**ALLSTAR TECHNICAL NOTE**

**Product: Commercial Operators, AU, T, J, H and MO-Series**

**Subject: New Reversing Contactor**

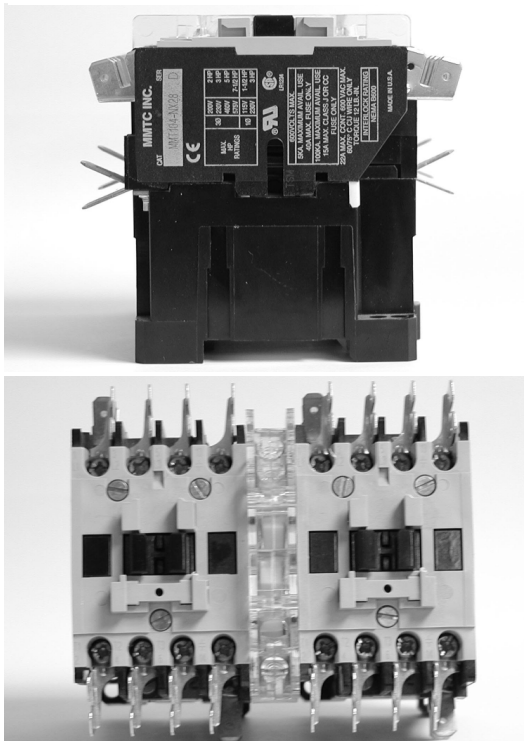
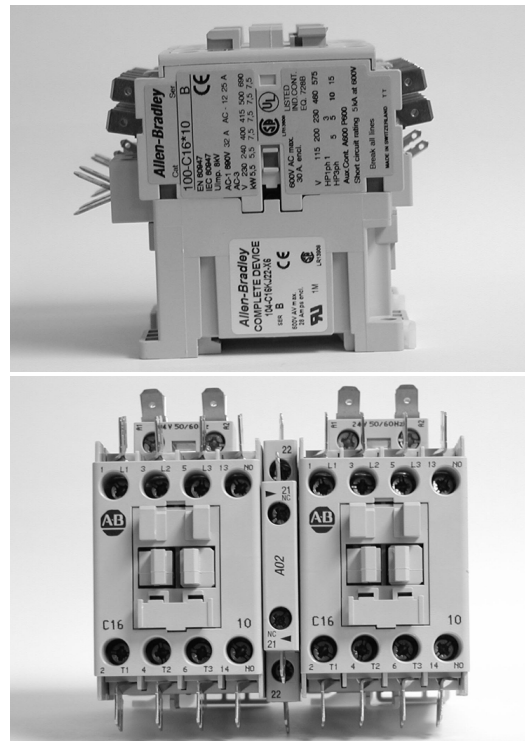
The manufacture of the mechanically interlocked reversing contactor used throughout the industry in commercial operators, and in Allstar commercial operators, has discontinued production of their MMT104-NX28 device. The replacement part is the 100-C16\*10 reversing contactor.

While functionally and electrically identical, the “100-C” is slightly larger than the “MMT104” and the mounting hole pattern is different and the required changes are incorporated into all new production. However, field replacement of the “MMT104” with the “100-C” will require repositioning of the reversing contactor in the control box and drilling new mounting holes.

Effective August 27th, 2001 (serial numbers starting with 3601), all Allstar commercial operators that require reversing contactors will be built with the “100-C” reversing contactor. Operators built prior to this date, using the “MMT104” reversing contactor, may still be in stock and will be use as required to fill orders.
